MAplication : 10/731,187
Filing Date : 12/09/2003
Inventors : Sivarama K. Kuchibhotla et al.
Title : **ILLUMINATION COMPENSATOR FOR CURVED
SURFACE LITHOGRAPHY**

Date : Friday, October 14, 2005

SECTION D – Remarks:

**In response to Office Action mailed 4/14/05, please accept the preceding
amendments , and these remarks:**

Fig. 9

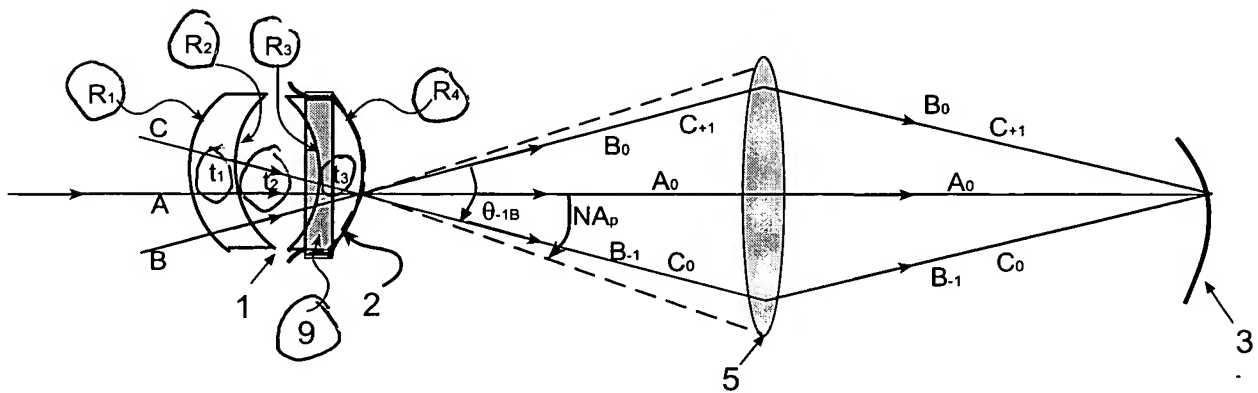
Drawings have been corrected by amendment in a replacement sheet. Acceptance of the corrected drawings is requested. These changes, which are being made pursuant to the Examiner's suggestion to conform existing drawings to existing written description, do not raise any issue of new matter. Designations R_1 , R_2 , R_3 , and R_4 and designations t_1 , t_2 and t_3 are now shown in Figure 9. Locking band 9 is now shown in Figure 9.
